Addendum Review of Environmental Factors

Cooma Hospital and Health Service– Key Worker Accommodation

4 July 2024

Figure 1 – Amended site plan under REF

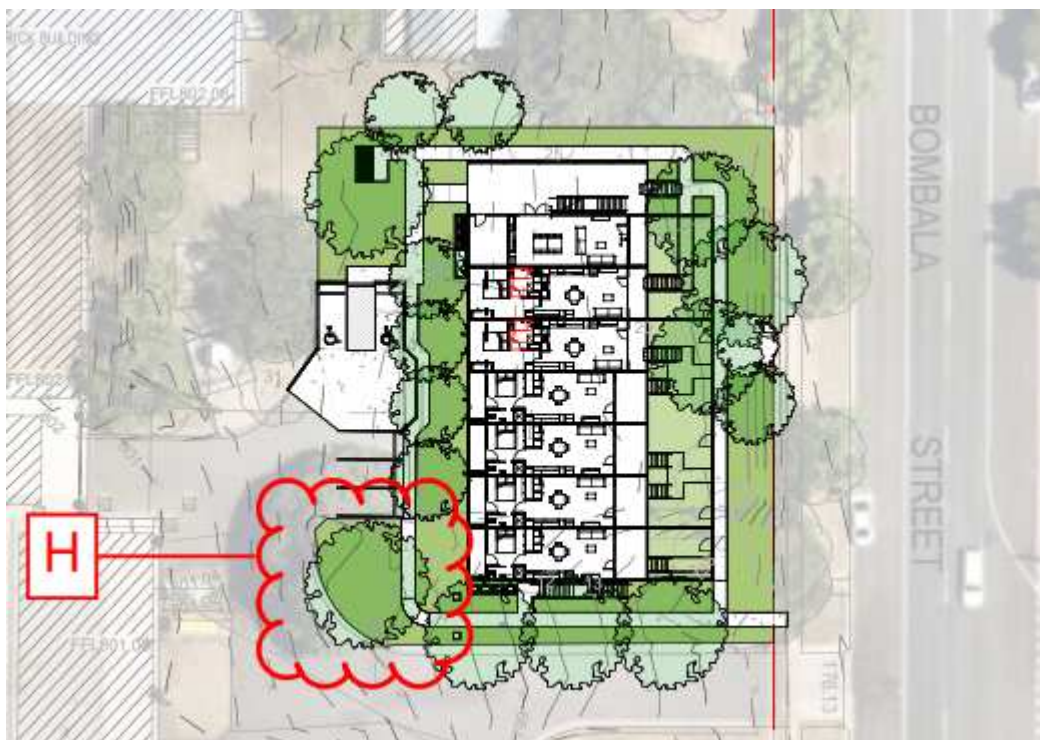
The following site plans in **Figure 1** shows the additional tree that is proposed to be removed under this Addendum:

As shown above, this Addendum seeks to remove one (1) additional tree, Tree 1001. This will result in a total of thirteen (13) trees being removed to facilitate the works. Tree 1001 is to be removed for the following reasons:

- The roots of the tree are causing damage to the stormwater drainage system
- The roots of the tree are causing damage and likely to further impact the driveway into the site and the kerb and gutter.
- During construction, the size and location of the tree will impact access to the site via crane. This will require significant pruning to the tree.

In support of the removal of Tree 1001, Abel Ecology has provided an updated arborist assessment dated 3 July 2024. The arborist statement is found at Appendix C. The report supports the removal of Tree 1001

Figure 3 – Amended North Elevation

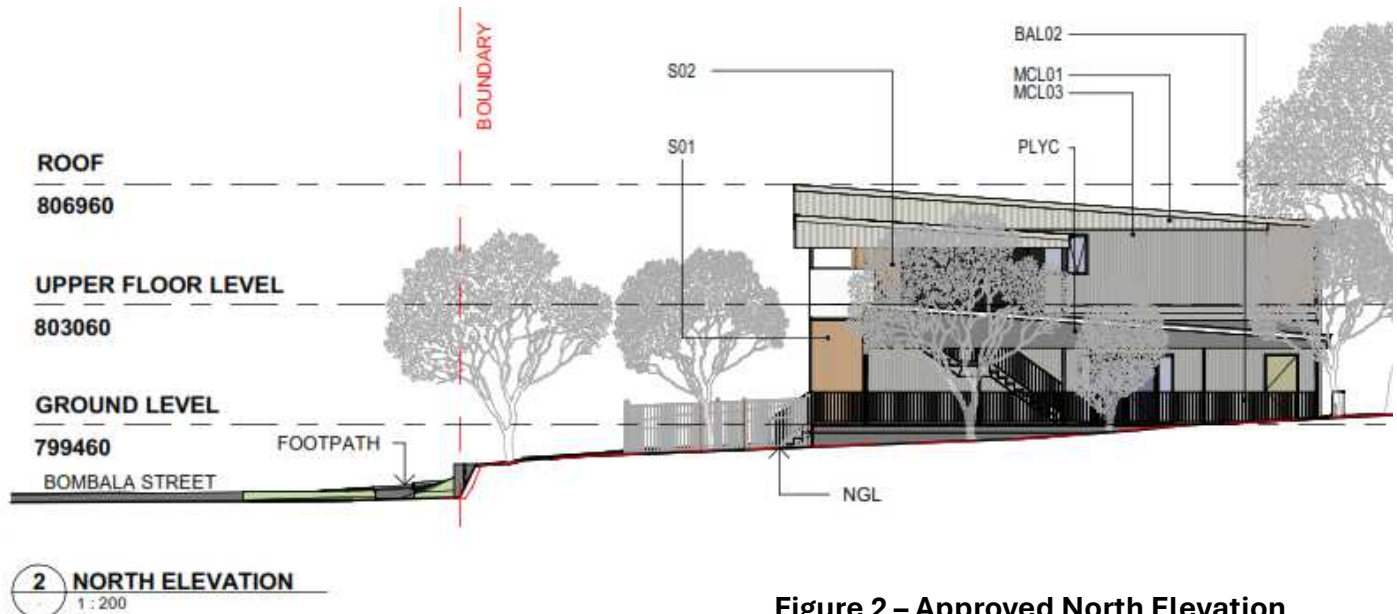
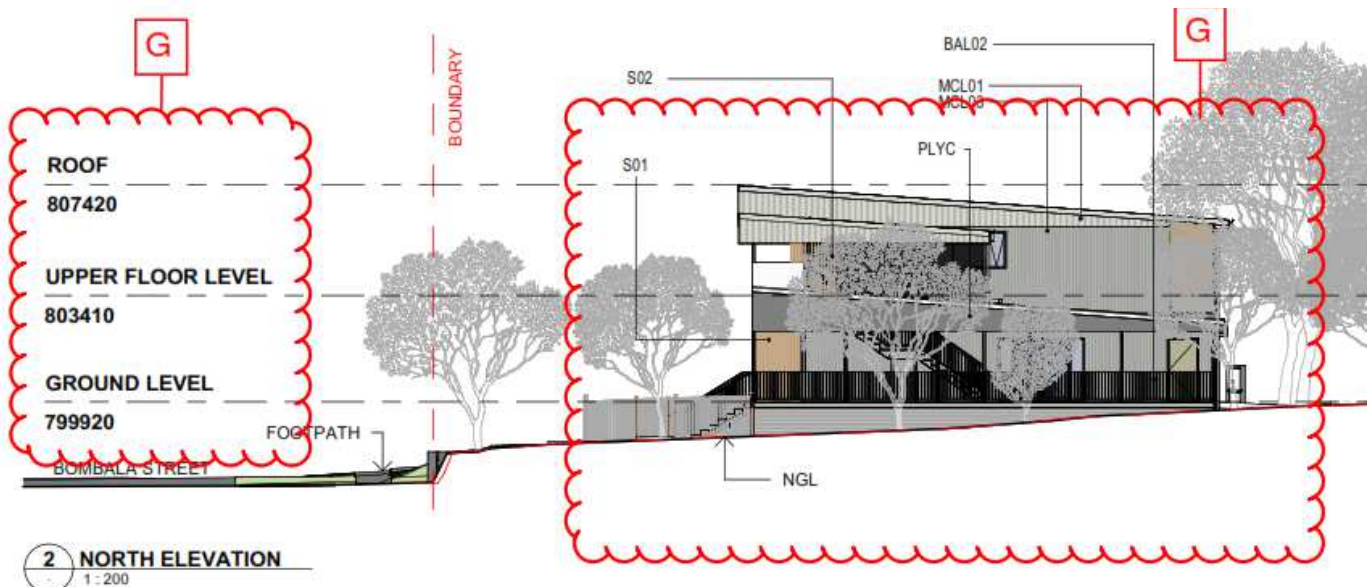
In addition, this Addendum seeks to raise the overall height of the buildings by 460mm. This is being done by increasing the finished floor level from RL 799.460 to RL 799.920.

The reason for the amendment is for a number of reasons. The soil excavation required to facilitate the approved design places a significant cost on the project and requires additional remediation. Reducing the excavation also assists with the remediation strategy to cap and contain should any further unexpected finds be located.

The accommodation block will be manufactured off site but once installed, on the piers and slab, will have a height as amended of 9.16m.

The height of the structure itself does not change, the overall height changes by the lifting of the ground level. This is demonstrated below:

The change in the overall height needs to consider whether this impacts the relationship with the heritage item. The overall height of the new building as amended will be higher than the heritage item. However there are key elements that ensure the relationship is appropriate and maintains a sympathetic transition including:

- Retains the separation of 10.66 metres between the new building and the heritage listed building
- The building remains two storeys in height, stepping down at the northern end to create an improved transition with the adjoining heritage listed building.
- Retention of recessive colours combined with materials and finishes, which incorporates metal cladding in two grey shades and painted and 'timber look' screens will result in a building form that will not adversely impact on the existing hospital buildings, in particular the heritage listed early building to the north.
- The unobstructed site lines to the heritage item are not impact by the change in levels.
